OVER THE SOLDERING IRON

PREPARED FOR THE INFORMATION OF RCA
VICTOR DISTRIBUTORS' SERVICE MANAGERS

SERVICE DIVISION-RCA MANUFACTURING COMPANY, INC.-CAMDEN, N.J.-NOVEMBER 10, 1938

VIEW OF FLYWHEEL

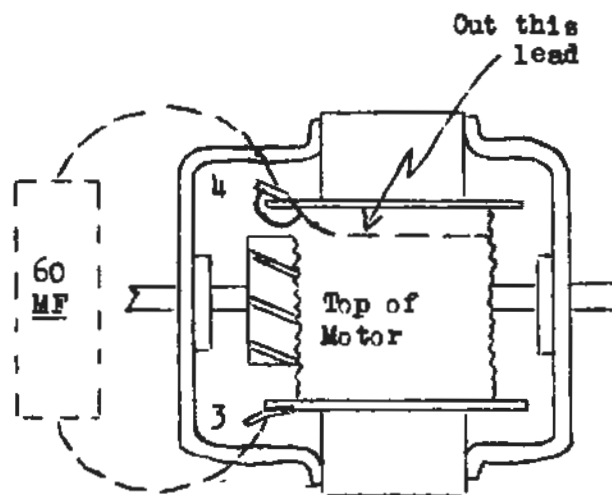
A revised design of flywheel has been employed on the drive motor of current line electric tuning models. This flywheel is available for replacement use, and is stocked as part #31240. The illustration to the left shows the modified arrangement, which has two leather friction pads with adjustment provided for each. The use of two pads reduces the pressure required for ideal adjustment and thereby lessens wear and glazing to a point where stable operation and normal stopping of dial pointer continues indefinitely. These flywheels are also balanced so that each one passes a very stringent factory test; this being an influence in obtaining good adjustment as well as in keeping mechanical vibration to a minimum. When installing a flywheel, it is very important to have the leather friction pads thoroughly saturated with "Neat-foot" oil; they should be soaked in this oil for at least 24 hours.

INSTALLATION OF LOUDSPEAKER CONES

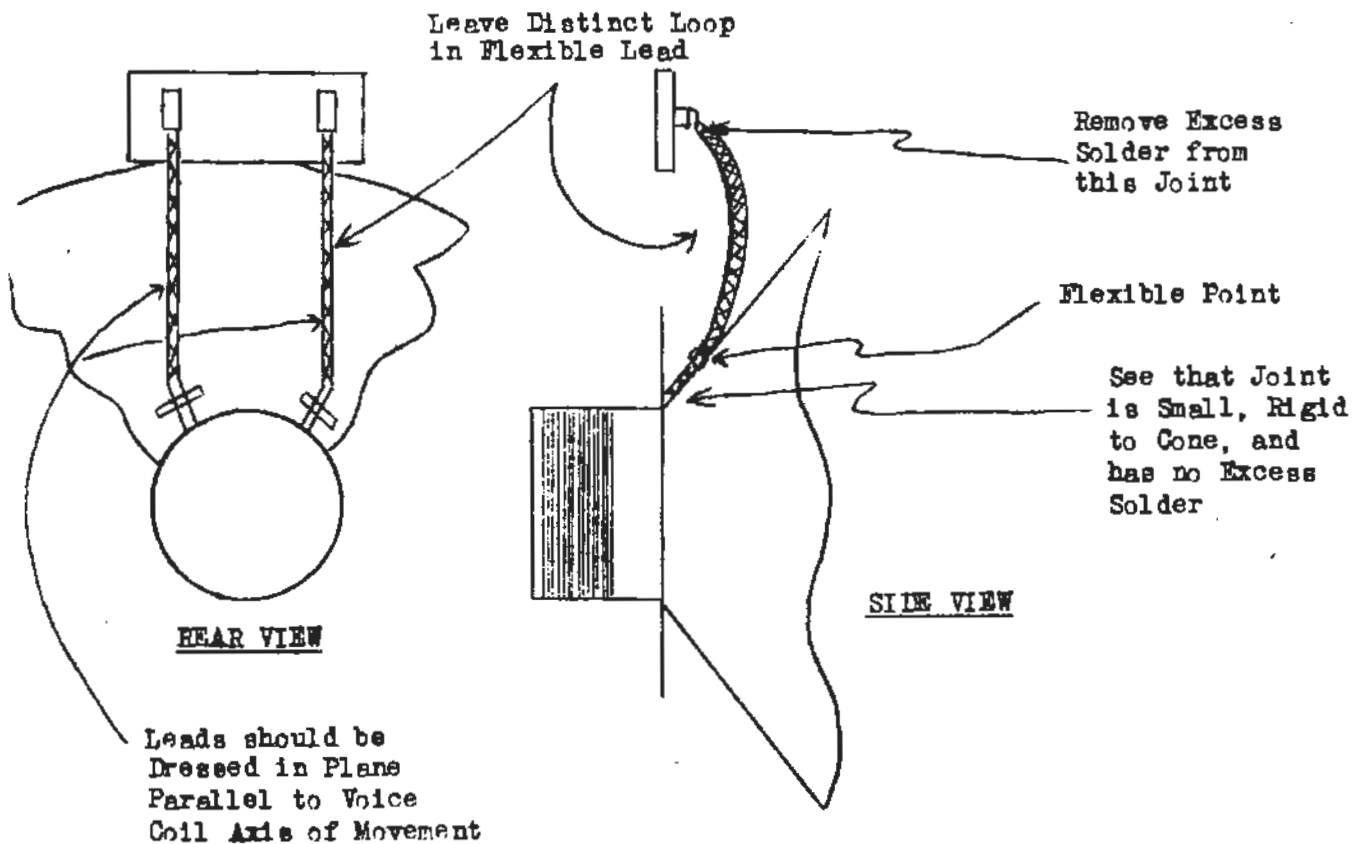
The illustration and notes below give the proper method of attaching and dressing voice coil flexible leads so as to prevent a "spiraling" or "twisting" effect during operation, which may ultimately result in lead breakage.

- (1) It is important to avoid "stiffening" of the flexible lead at the ends by allowing solder to flow beyond the joint into braid.
- (2) The cone end of the lead should be secured by a staple over a "flexible" point of the lead.
- (3) See that the terminal strip or outer ends of the leads are secured in approximately the same plane with the stapled ends on the cone.
- (4) A definite "loop" or "slack" must be provided in the leads; and must be in the plane of motion as illustrated above.
- (5) The flexible leads on replacement cones are cut to the proper length, so as to allow for correct forming of a loop when one turn is made around soldering lug at the extreme end.
